In Reply Refer To: HSSD/CC-26I

Name of device/system: Optimized version of a 9-cylinder REACT 350®  
Type of device/system: Redirective non-gating impact attenuator  
Test Level: NCHRP Report 350 Test Level 3 (TL-3)  
Testing conducted by: E-TECH Testing Services  
Date of request: November 12, 2007

REACT 350<sup>®</sup> SYSTEM  
W/SELF CONTAINED BACKUP  
FULLY SELF-RESTORING

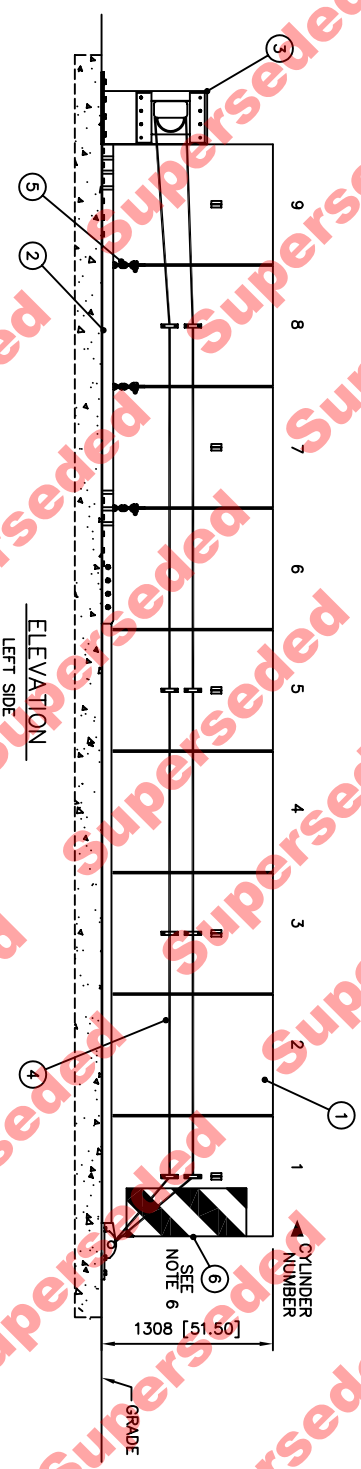
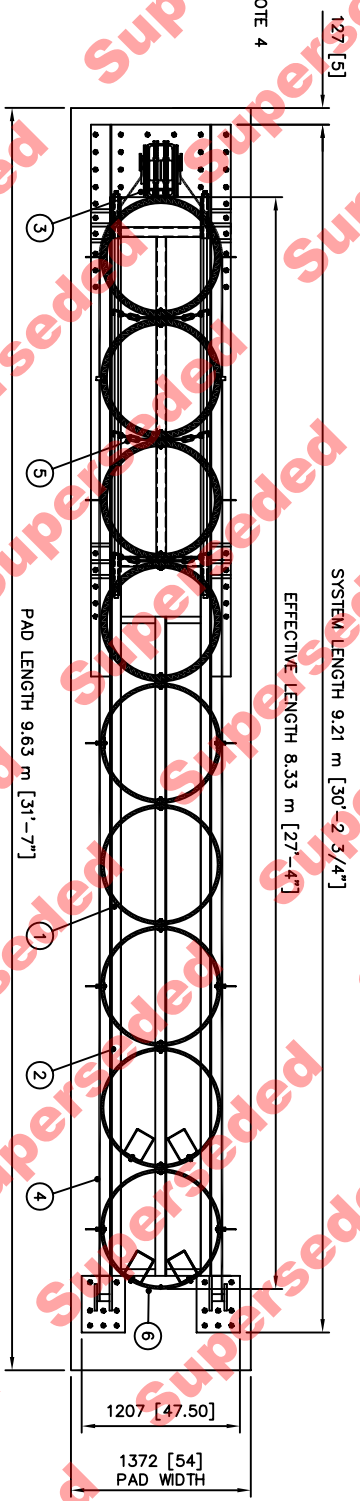
The optimized system modified the rear four cylinders by making them slightly thicker and more robust. To support your request, you supplied an NCHRP 350 compliance report prepared by E-TECH Testing Services, Inc. that describes the REACT 350<sup>®</sup> as well as the three full-scale crash tests you conducted on this attenuator.

Based upon the successful completion of the aforementioned NCHRP 350 tests you provided, we agree that your 9 cylinder TL-3 model of the REACT 350<sup>®</sup> redirective, non-gating crash cushion can be used in temporary or permanent installations for both uni- and bi-directional traffic applications when appropriately transitioned and anchored. The system as described above may be used on the NHS when such use is acceptable to the contracting authority.
